# SAFETY ALERT

Safety Alert No.: D99-RRV2015-SA-001

**Titan BX Pressure Relief Valve**

**Subject:** Structural failure of a Titan Type BX pneumatically-operated pressure relief valve, and required inspection, system considerations, and recommended modification of such valves. This Safety Alert has been issued as a follow-up to NOV Product Information Bulletin (PIB) number D99-RRV2015-PIB-001, issued March 30, 2015.

**Figure 1: Titan BX Valve and Actuator:**

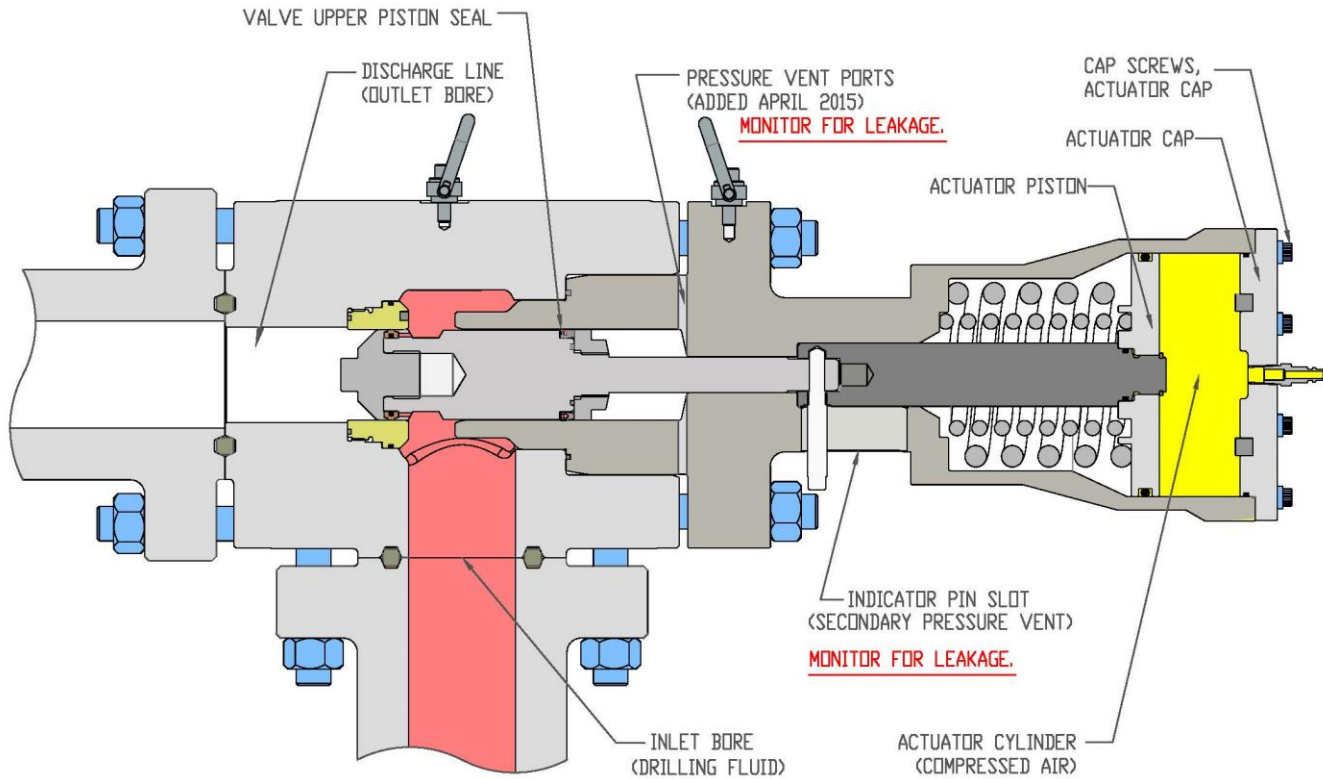
Specific locations to monitor for leakage of the upper piston seal are shown in Figure 1:

- a) For all Titan BX valves, leakage of drilling fluid from the slot for the position indicator pin indicates leakage of the valve piston upper seal.
- b) Titan BX valves manufactured after April 1, 2015 have four ports located just below the bonnet flange to improve venting of fluid and pressure that leaks past the valve piston upper seal.

NOV recommends that owners of existing Titan BX valves manufactured prior to April 1, 2015 contact NOV to have the vent ports added. The vent ports are shown in Figure 1 and described above in part 1.b).

The Titan BX relief valve should be visually inspected every day of operation for external evidence of leakage of mud past the upper seals on the valve piston. If leakage of drilling fluid is observed, immediate action must be taken to repair or replace the valve and eliminate the leak.
